**Written comments with CAISO reply
Submitted after the
November 24 Stakeholder Meeting regarding the
2011 Local Capacity Requirement (LCR)
Criteria and Methodology and the
2011 LCR Manual**

2011 LCR Study Criteria, Methodology and Assumptions

The following are comments submitted on behalf of City and County of San Francisco (CCSF) on the CAISO Draft Manual for the 2011 Local Capacity Area Technical Study document dated November 5, 2009.

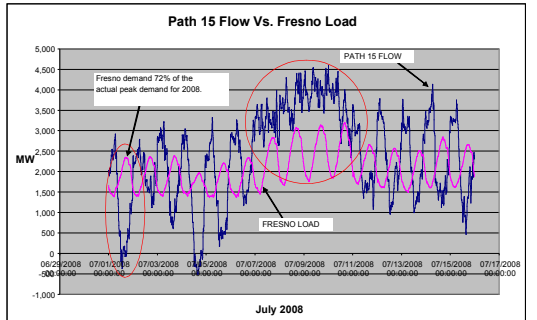
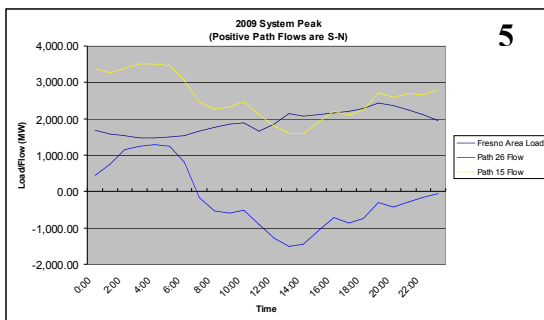
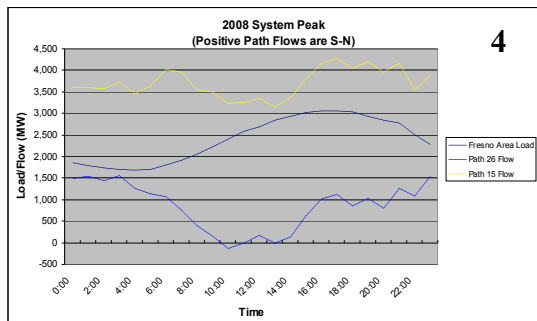
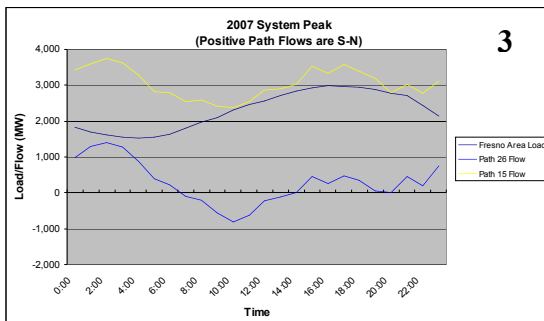
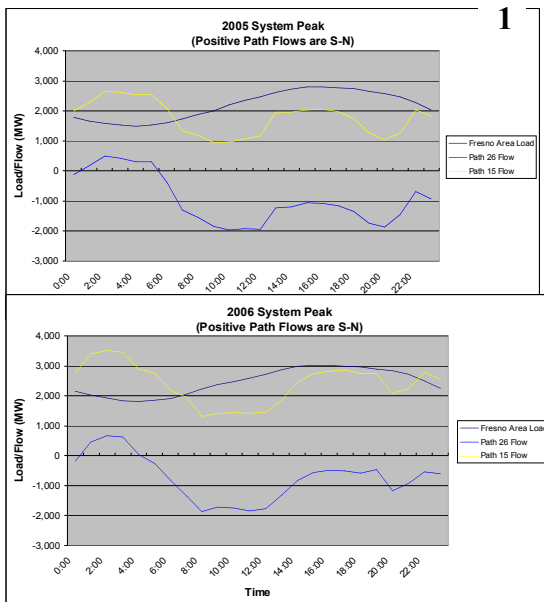
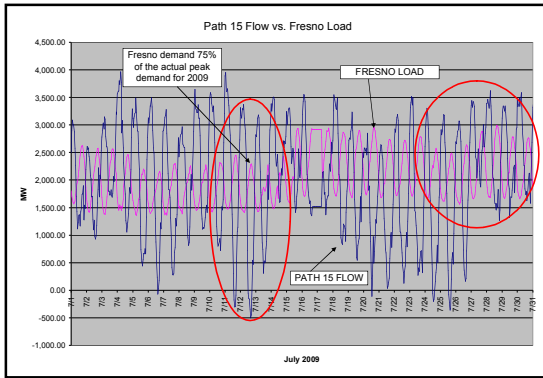
1. Path 15 – In the Draft Manual and meeting presentation, the CAISO has indicated that the Path 15 Flow will be kept constant at 1275 MW North to South (N-S) for the purpose of the 2011 Fresno Area LCR Studies. PG&E believes that this is a very unrealistic assumption to make that unreasonably increases the LCR for the Fresno Area.

PG&E has analyzed Path 15 real-time data, which revealed that, for the past five years, the Path 15 flow has not been in the N-S direction during the Fresno area peak demand days. Typically, the Fresno area load peaks on the same days when the overall PG&E system peaks. Charts 1 – 5 below present the actual Fresno area load on the days the PG&E system peaked for the years 2005 to 2009. The charts show that on Fresno (and System) peak loading days, flows on Path 15 can be well over 2000 MW in the south to north direction (S-N). In addition, the charts indicate that during these periods of high loading conditions, the N-S flow on Path 26 also decreases in relation to the Path 15 flow.

Additional data analysis indicates that N-S flow on Path 15 can occur during the summer time. However, this happens on non-peak days when the Fresno load demand is about 25% lower than the actual peak demand for the year. Chart 6 and 7 present examples of the Fresno load demand and Path 15 flows for the month of July 2008 and July 2009. Both charts show a few days during the month when the Path 15 flow was in the N-S (~500 MW) direction but it also shows that the Path 15 flow will generally increase in the S-N direction as the Fresno area demand increases during the summer peak periods. PG&E would like to note that high N-S flow on Path 15 during summer peak periods, as proposed in the LCR Manual, is only possible when most of the generation south of the Fresno area is offline (on occasion this could include Diablo Canyon).

PG&E understands that the local capacity requirements study is inclined towards determining the local areas capacity needs under worst case scenarios. However, based on the real-time data, it is unrealistic to assume that the Path 15 flow will be 1275 MW in the N-S direction during Fresno area peak loading conditions. For the above reasons, PG&E recommends at a minimum, a range of -250 to 250 MW N-S flow on the Path 15 be acceptable for the purpose of the Fresno Area LCR studies. Assigning a range for the Path 15 will more accurately reflect the LCR needs of the local Fresno Area and it will also eliminate the need for adjusting the Path 15 flow after different steps in performing the local capacity technical study.

CAISO response: The data submitted shows significant changes between different peak days and years and not a consistent pattern. The July 2008 data could be used to justify a 4500 MW S-N flow; whereas the July 2009 data shows high Fresno peak days with Path 15 flow in the N-S direction. The ISO finds that the data submitted does not justify PG&E's proposed range of -250 to +250 MW N-S Path 15 flow but rather a 5000 MW swing between 4500 MW S-N and 500 MW N-S flow. The Path 15 flow at the time of Fresno peak must allow the ISO to manage Fresno constraints without market impact on Path 15. At this time, the ISO does not believe that data conclusively supports a change to the previously agreed upon assumption. However, ISO will further review the issue.
